RE: ZBA2026-083, 248 Vinton Street, B-2

Zoning Relief Required for Building Permit

ZONING REVIEW

BOUNDARY SURVEY
SUSAN G. JEAN FAMILY REVOCABLE TRUST
MANCHESTER, NEW HAMPSHIRE

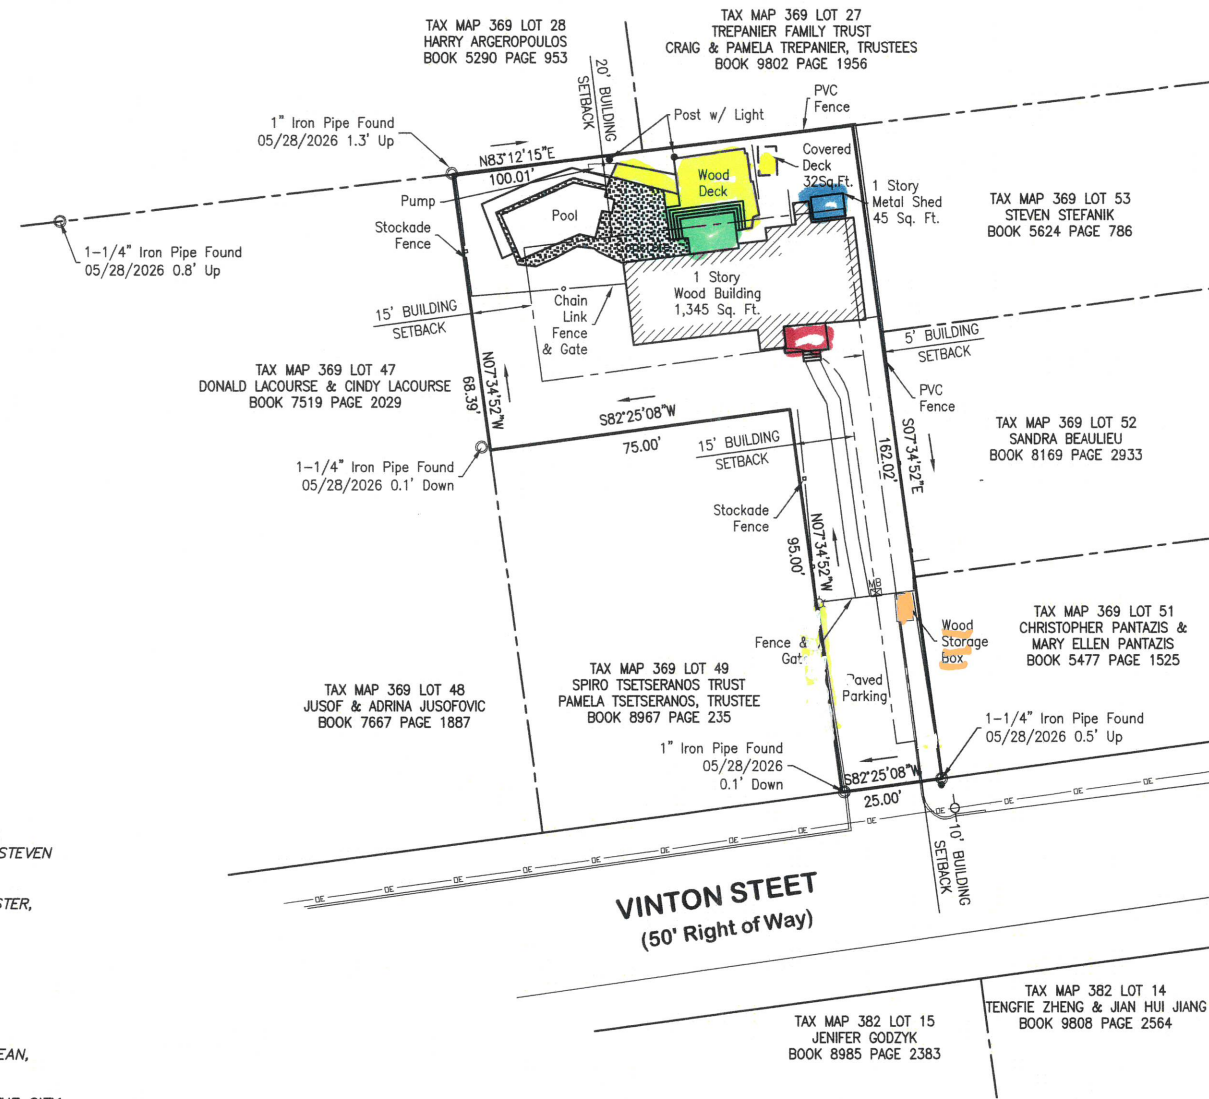
Article 5 Accessory Structures			Section	Permitted/ Required	Proposed/ Existing	Remarks
☒	Setback	Front/Street Yards	5.6	Not Allowed	Storage Box	N/C
☐		Side Yard		Match Primary Structure	See Plan	OK
☒		Rear Yard		4 ft.	2 ft. & 14 ft.	N/C - Covered Deck. OK - Shed
☐	Height	Side Yard	5.6		N/A	OK
		Rear Yard		See Ord.	Proposed	OK
☐	Size Limits	Side Yard	5.6		N/A	
		Rear Yard
